**Project #19-031
Kearl Property
1136 N 600 W**

Project Name: Kearl Property
Proponent/Owner: Travis Taylor / Leanard C. Kearl Jr. Trust
Project Address: Approximate 1136 N 600 W
Request: Rezone from NR-6 to MR-9, Subdivision and Design Review Permit
Current Zoning: NR-6
Date of Hearing: September 12, 2019
Type of Action: Legislative, Quasi-Judicial
Submitted By: Aaron Smith, Planner II

SPANNING TITLE
Elevations

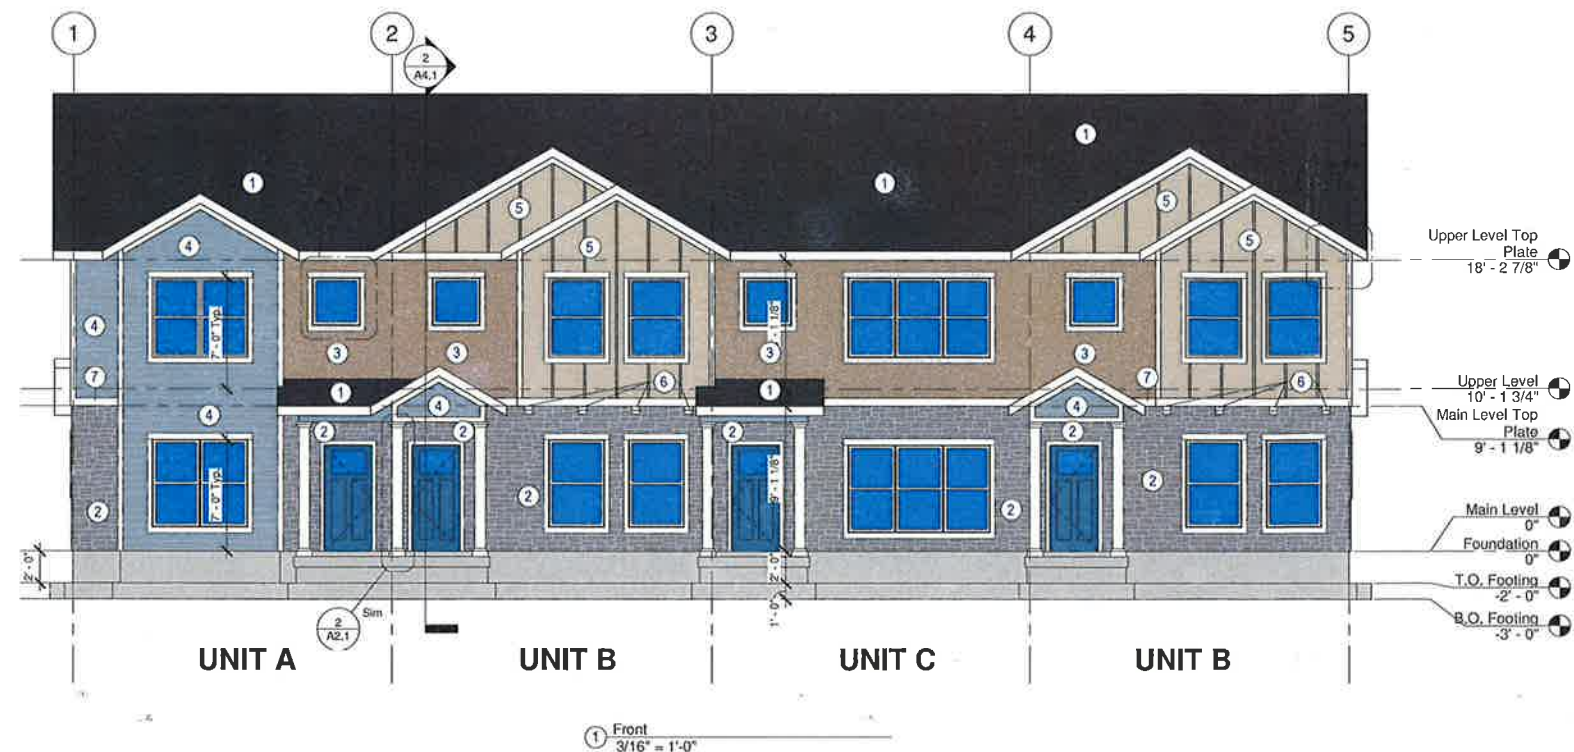
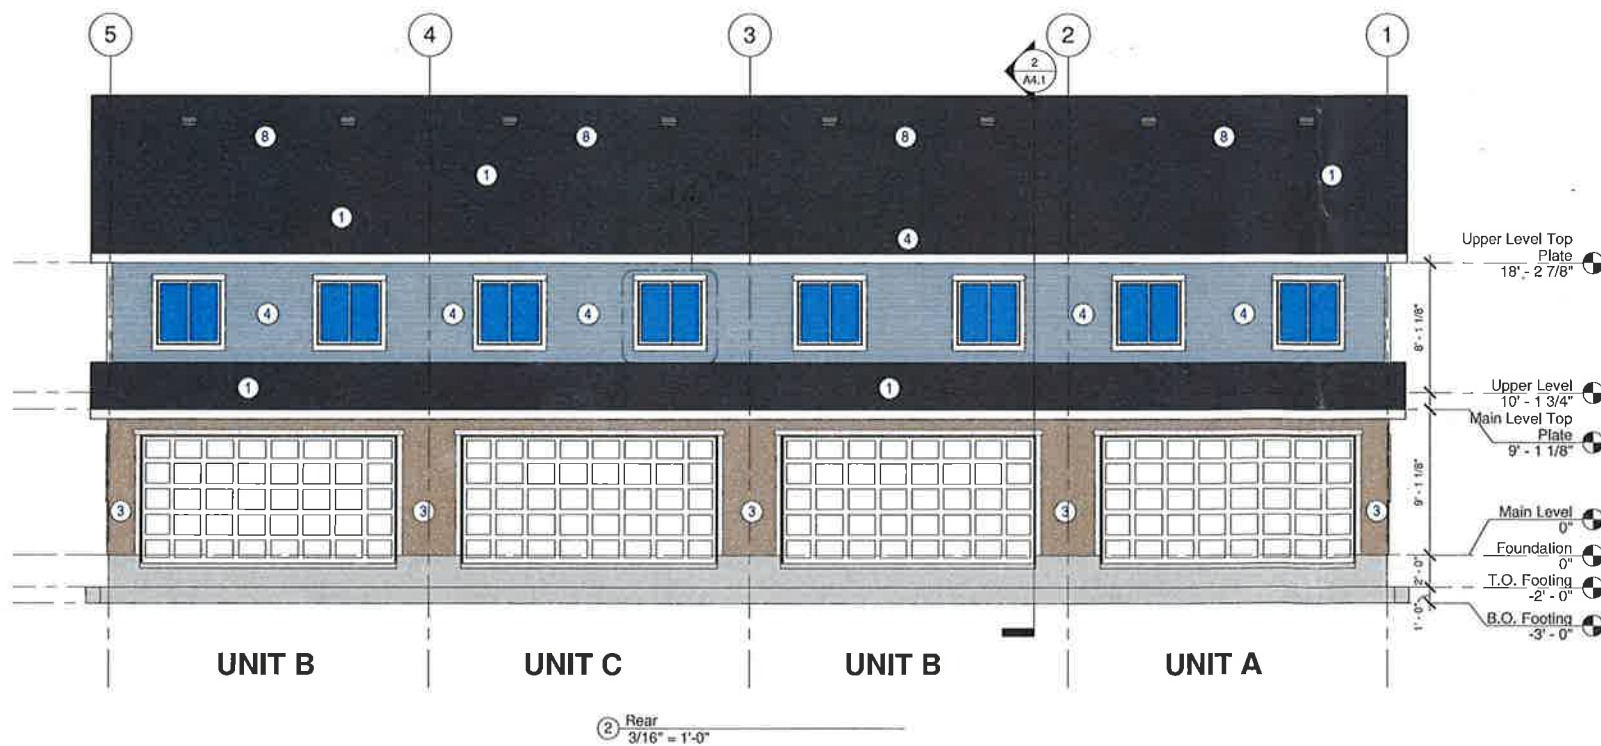
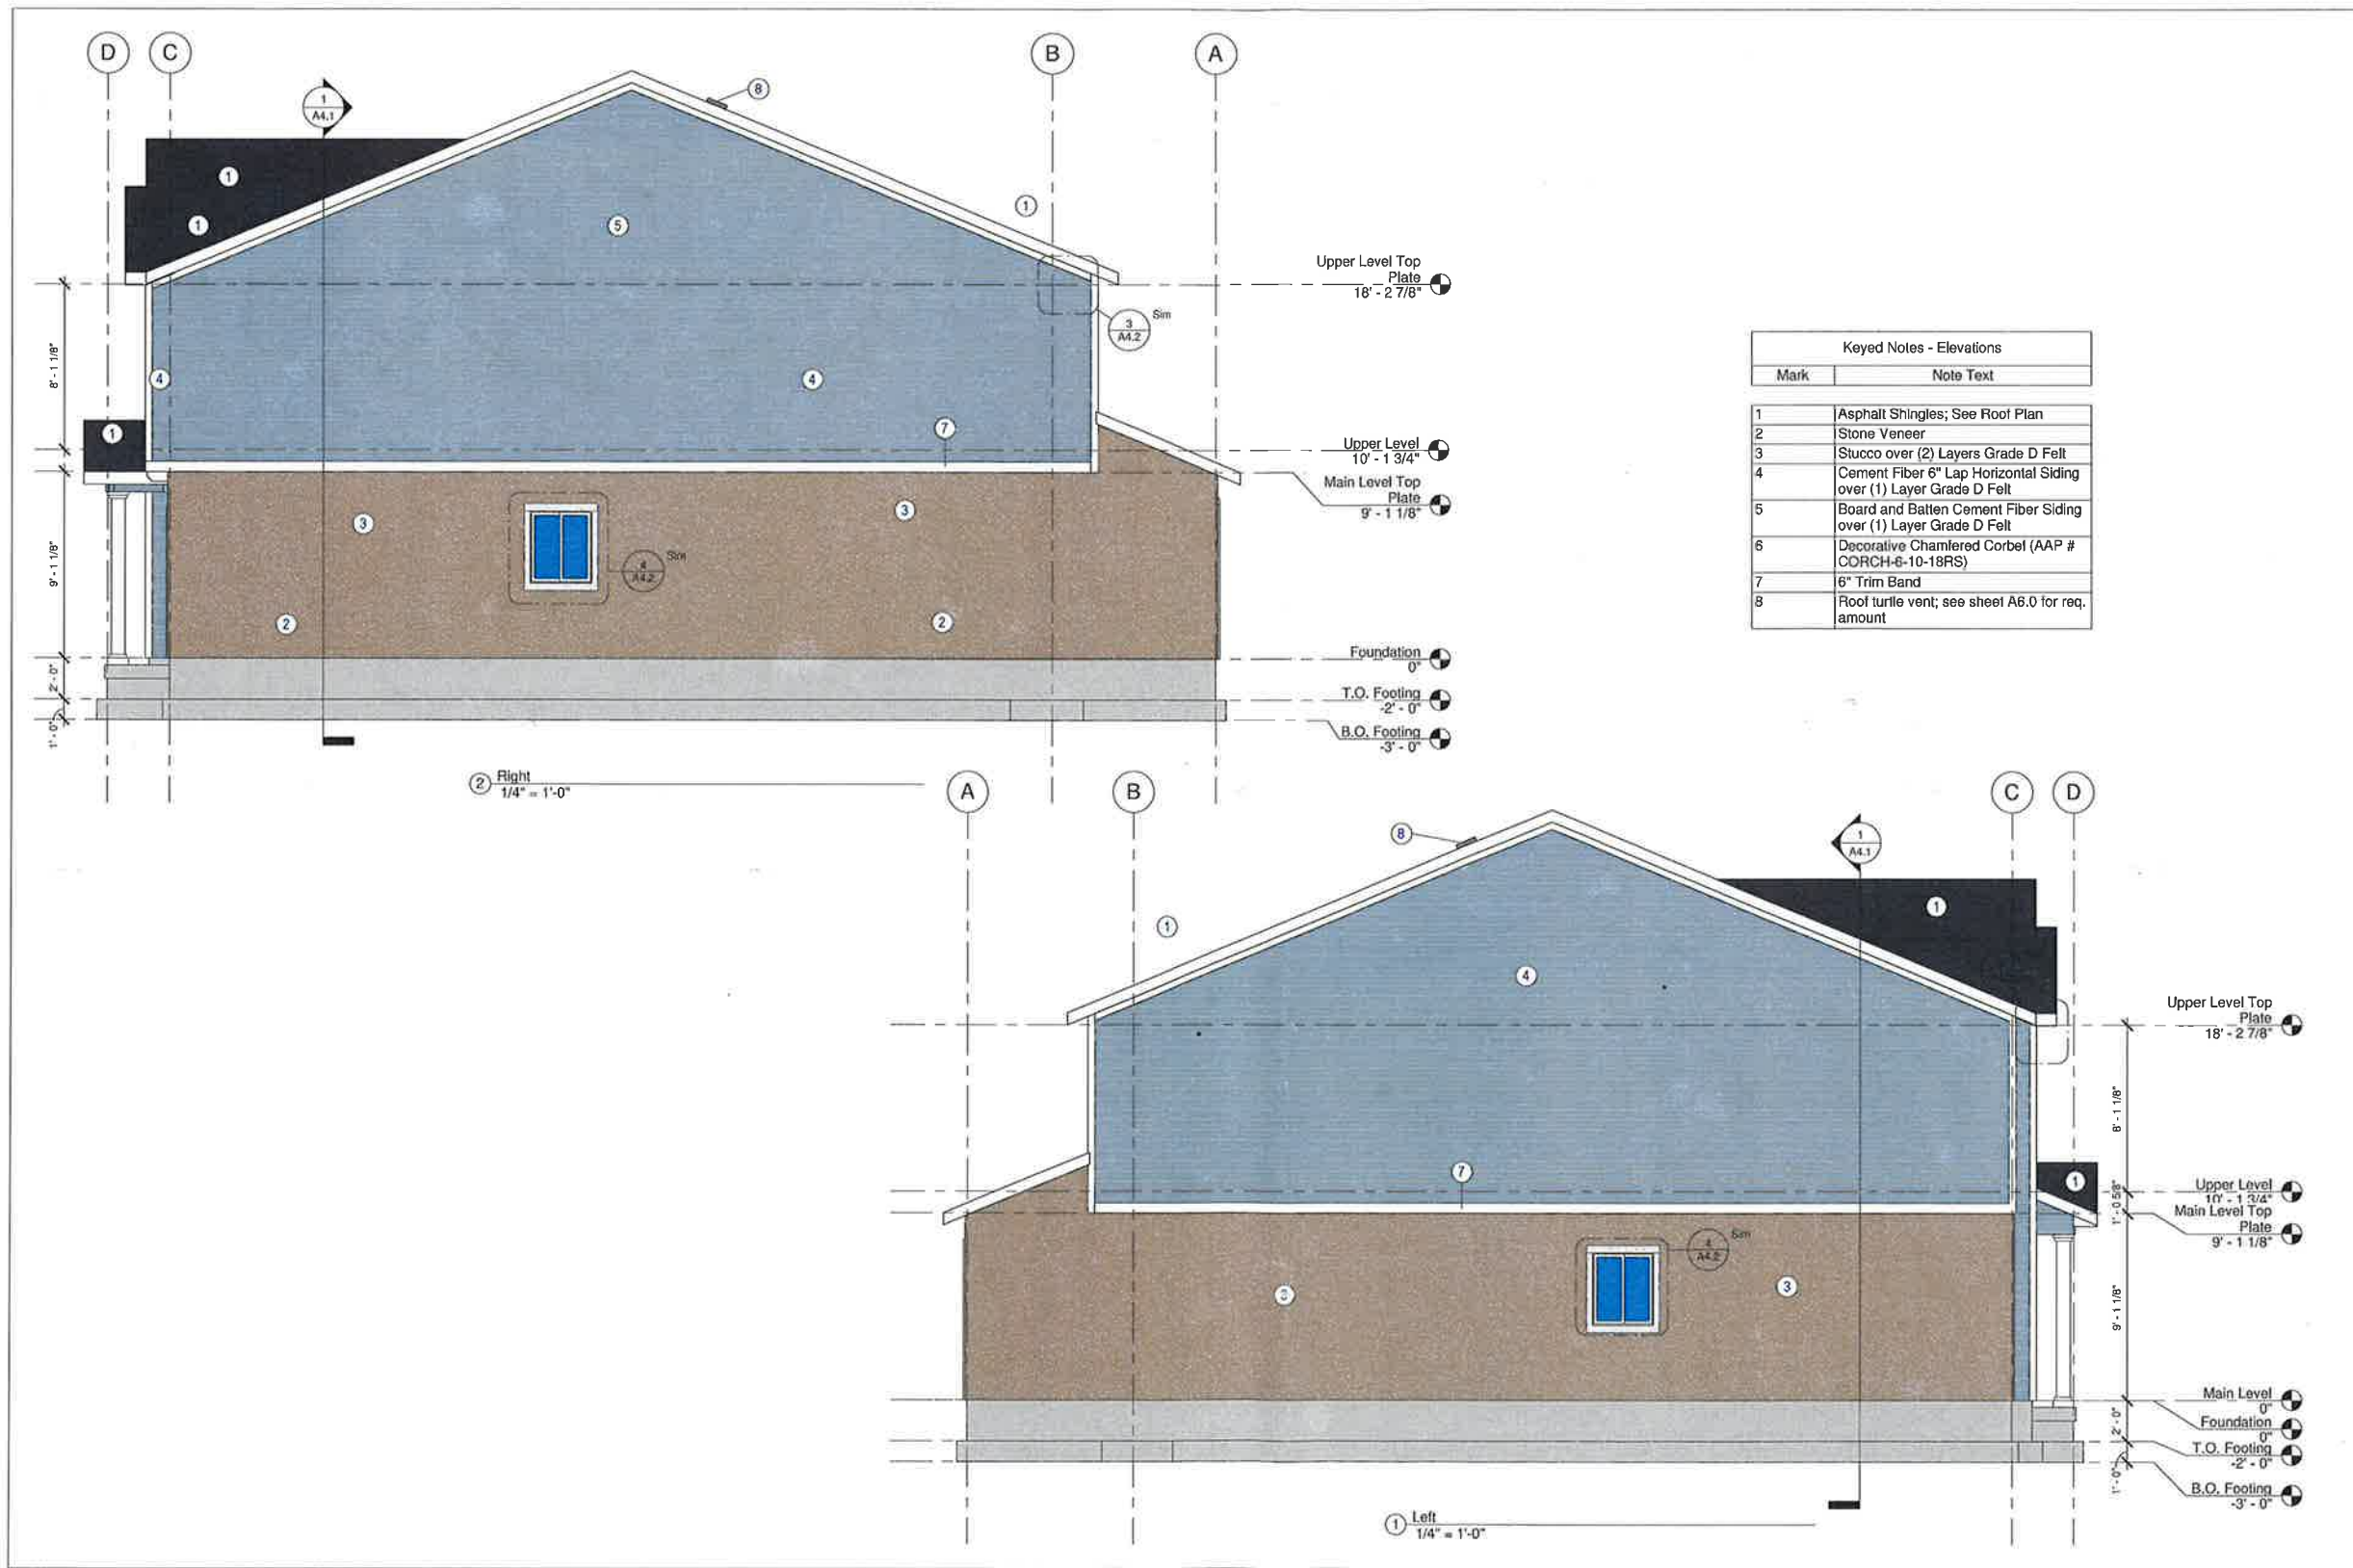
In the MR-9 zone, the LDC requires that no two adjacent buildings can share the same elevations. The LDC identifies eight (8) different categories and requires that at least four (4) out of the eight (8) be noticeably different. The eight (8) categories listed are building color, materials, roofline, height (number of floors), fenestration, architectural style, articulation and porch design. The proposal includes only one elevation for the buildings. As conditioned, with adjacent façades that vary by at least four (4) out of the eight (8) design categories listed in the LDC, the project meets the requirements of the LDC.

Porches and stoops are required to be a minimum of 4' in depth. The proposed stoop for each unit is shown as only 2'. As conditioned, with a minimum 4' stoop or porch for all units, the project meets the requirements of the LDC.

8. No two adjacent buildings shall have the same street facing façade design and must vary at least four (4) out of the eight (8) design categories listed in the LDC 17.09.040.

9. Front porches and stoops shall be a minimum of 4' in depth.
10. The Planning Commission reduces the street connection requirement from three (3) connections to two (2) connections, as site constraints prohibit additional street connections.
